Revise the Technical Specification as follows:

Proposed Technical Specification Change No. 139
Safety Analysis

Description of amendment request: The proposed amendment would revise the radioactive effluent specifications to reflect Draft Revision 5 of the Standard Technical Specifications by addressing effluent requirements applicable to each reactor unit, in accordance with the NRC staff position provided by letter dated May 7, 1987, and would incorporate other changes for additional clarification. The following changes have been incorporated.

FIGURE 5.1-1

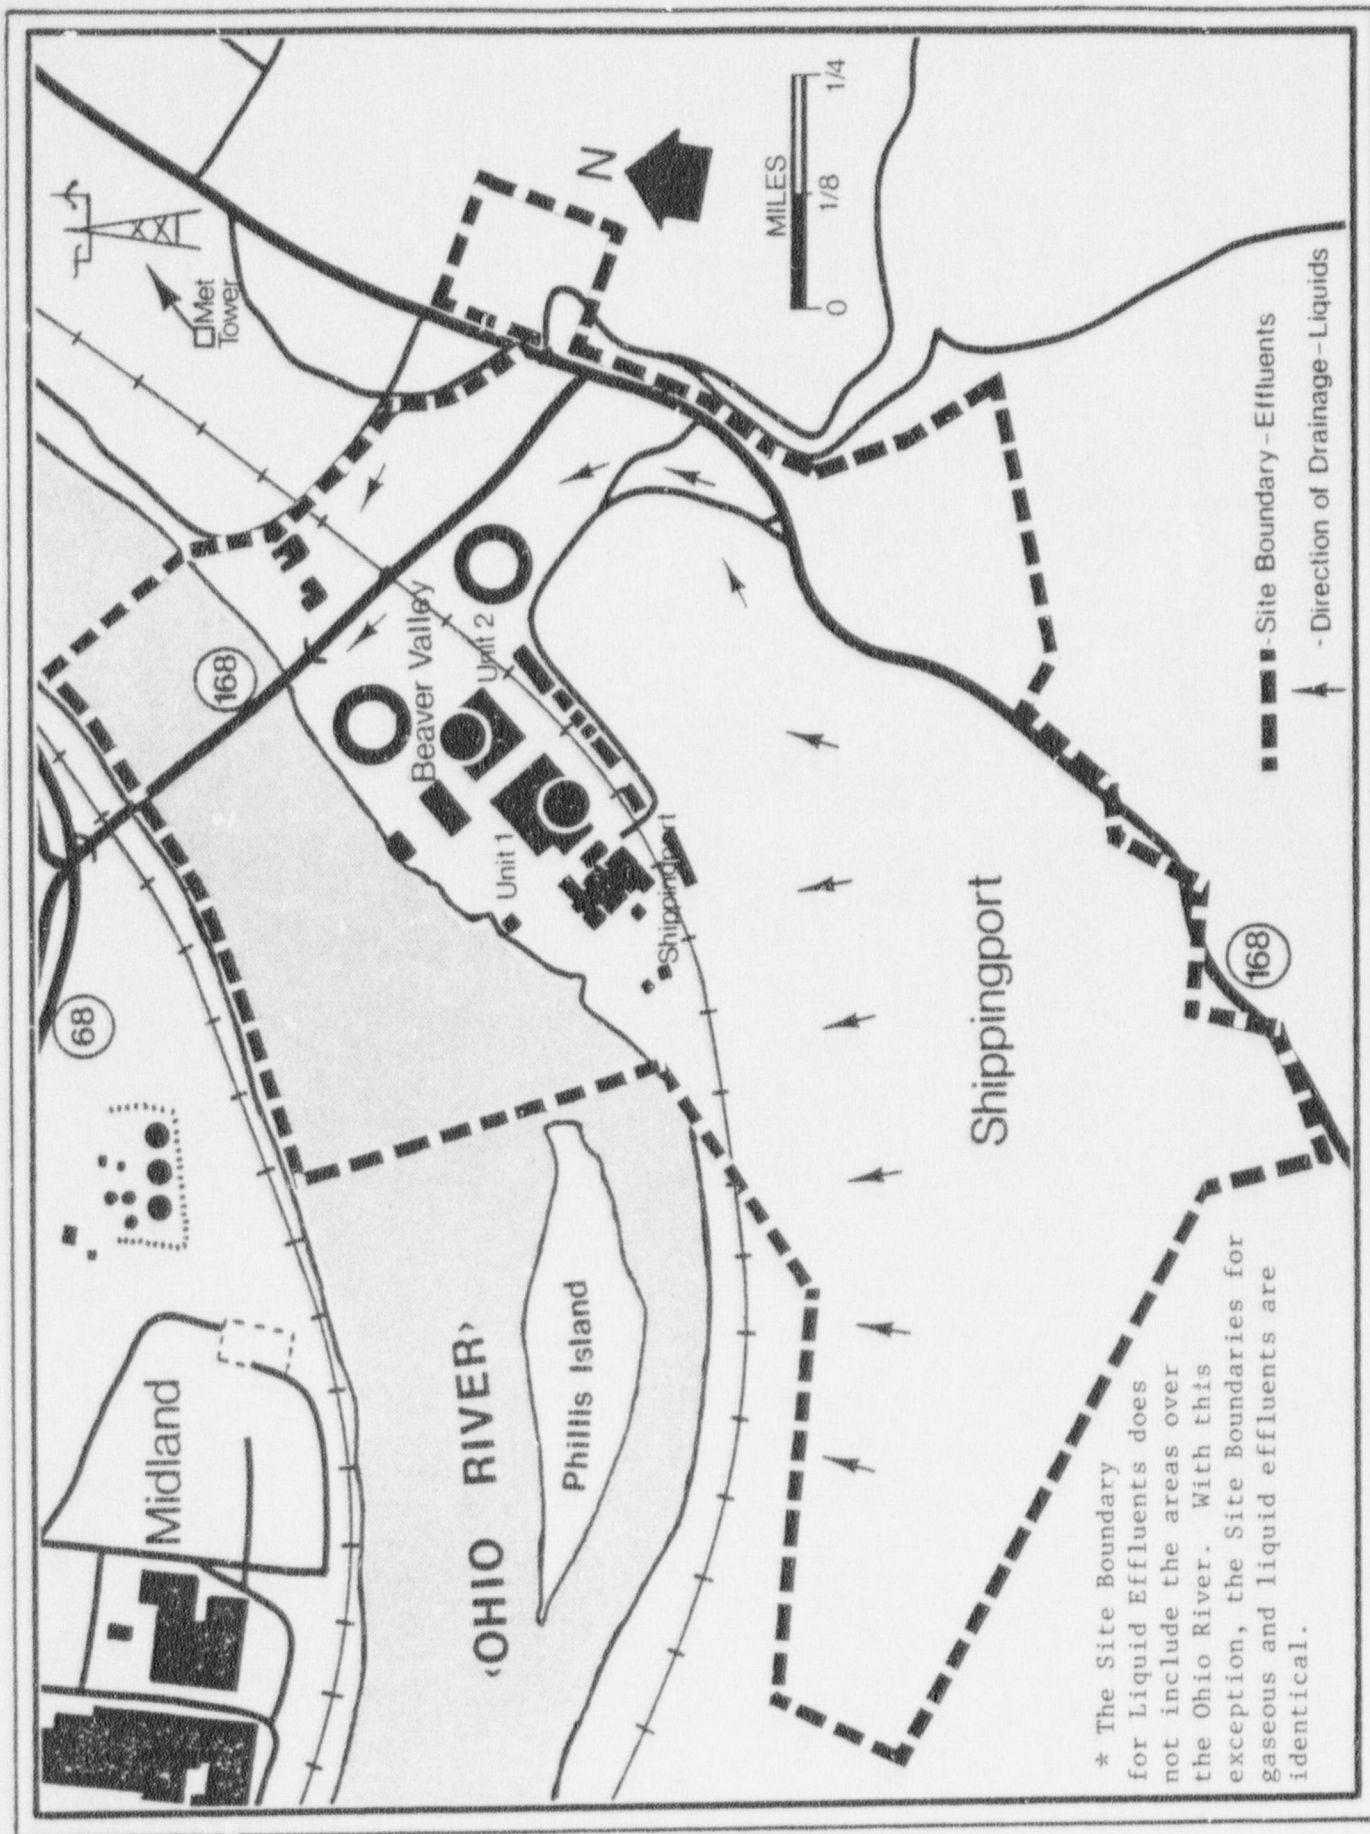
14. Page 5-1b, Figure 5.1-1 has been revised by changing the title to address liquid effluents. An * note provides clarification of the site boundary for liquid effluents since this is identical to the site boundary for gaseous effluents except for that area over the Ohio river. A note "(next page is 5-1d)" has been added since the next page (5-1c) is being deleted.

15. Page 5-1c, Figure 5.1-2 is being deleted since the site boundary for liquid effluents is being added to Figure 5.1-1.

has been corrected to accurately specify that the limiting basis for determining the thyroid dose rate is based on that dose received by a child from the inhalation pathway. Since Figure 5.1-2 is identical to Figure 5.1-1, except for the title, Figure 5.1-2 is has been deleted and the title has been revised to identify the site boundary for liquid effluents. Therefore, these changes are administrative in nature providing clarification, consistency and improved accuracy to simplify and improve the understanding of the requirements and do not affect the probability of occurrence or the consequence of a previously evaluated accident.
